PARTS & SERVICE NEWS

REF NO.	AT99029
DATE	Apr. 12, 1999

SUBJECT: INTRODUCTION OF IMPROVED PARTS FOR T/C OIL SEAL ON HD785-3/-5, HD985-3/-5

PURPOSE: To introduce modification procedures to prevent penetration of water through the oil seal of the torque converter input shaft on HD785-3, HD785-5, HD985-3, HD985-5 and HV700-2 dump trucks

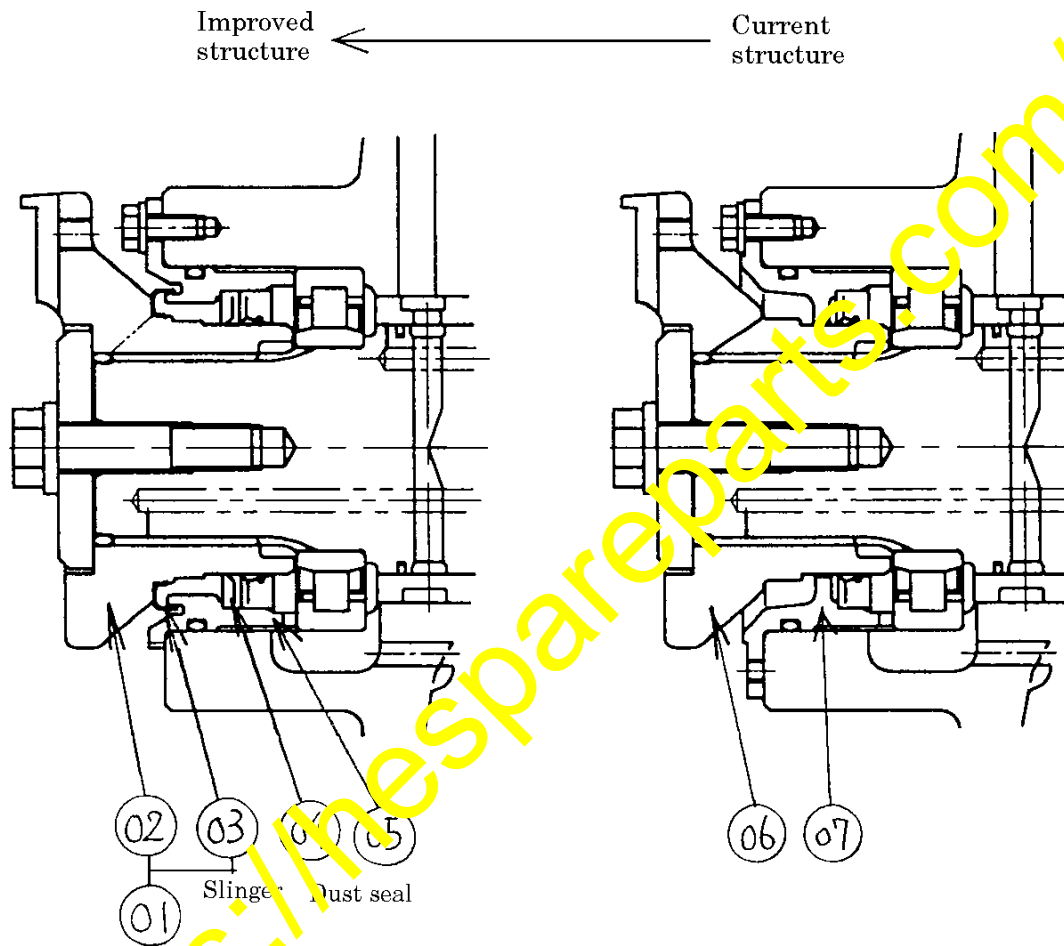
While the HD785-3, HD785-5, HD985-3, HD985-5 and HV700-2 dump trucks are being washed using pressurized water, water may penetrate through the oil seal for the torque converter input shaft causing deterioration of the oil seal leading, finally, to oil leakage.

To prevent such a failure, the structure is to be modified by adding the dust seal (04) and supplementing the slinger (03) to the coupling (02) and, along with this modification, the shape of the retainer (05) is changed to constitute a new structure to prevent entry of water and other foreign substances.

Assembly procedures

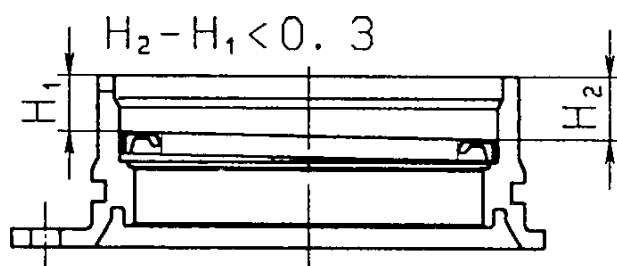
1. Apply liquid gasket LG-5 over the press-fitting surfaces of the oil seal and the dust seal. When applying the liquid gasket, do so lightly over the bore surface of the retainer and thoroughly wipe to clean the swollen portion of the liquid gasket.
2. Place the retainer on a level stand, press-fit the dust seal using a push-tool. Press-fit the dust seal into a position of 23.5 ± 0.3 from the end face of the retainer. Meanwhile, the inclination of the dimension 23.5 ± 0.3 should be within 0.3 mm.

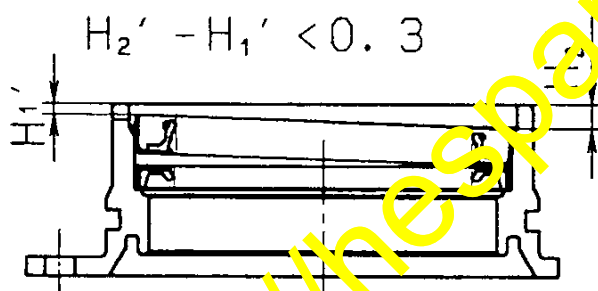
3. Place the retainer on a level stand, press-fit the oil seal using the push-tool. Press-fit the oil seal into a position of 9 ± 0.3 from the end face of the retainer. Meanwhile, the inclination of the dimension 9 ± 0.3 should be within 0.3 mm.

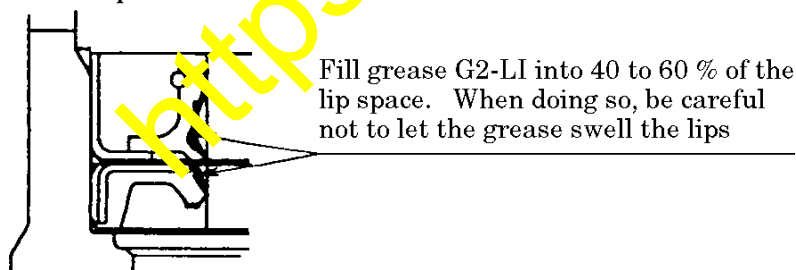
4. Fill grease G2-LI into the lip space and into the space between the oil seal and the dust seal.

Detail "P" (Enlarged view)

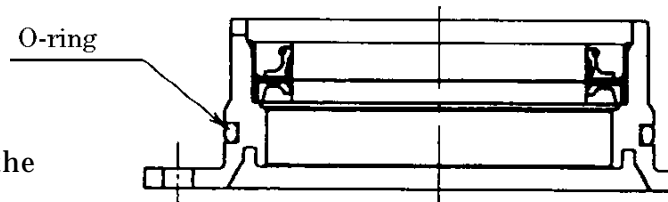
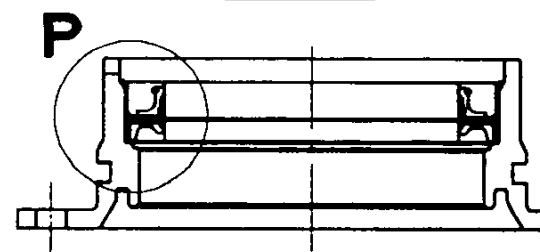
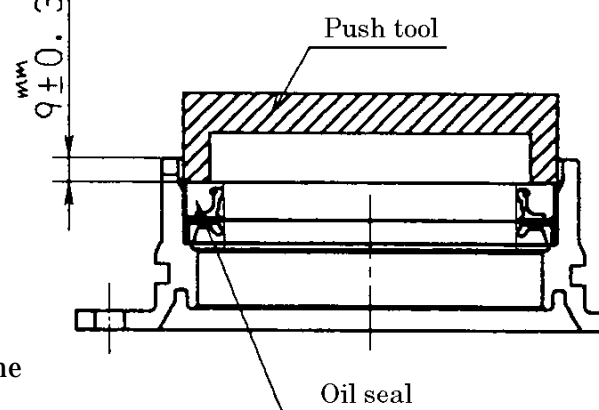
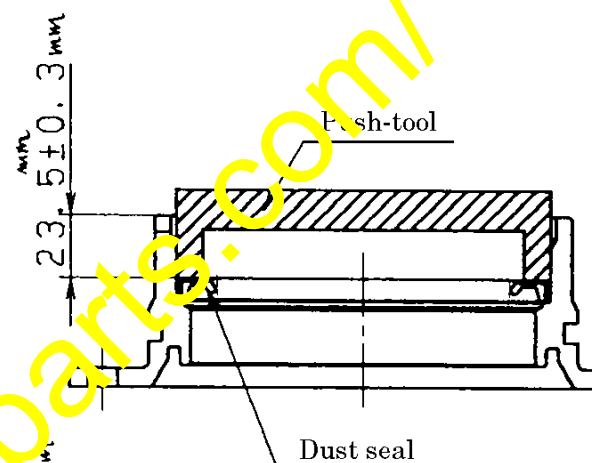
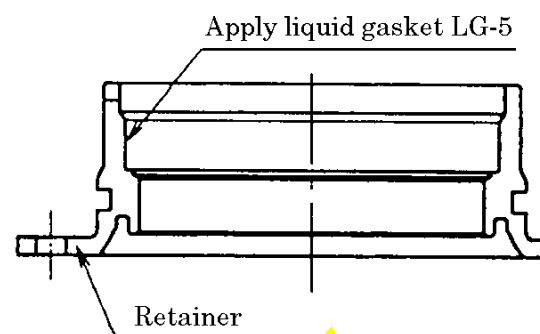
5. Set the O-ring to the retainer.
6. Install the retainer to the front case of the torque converter.
7. Install the coupling.
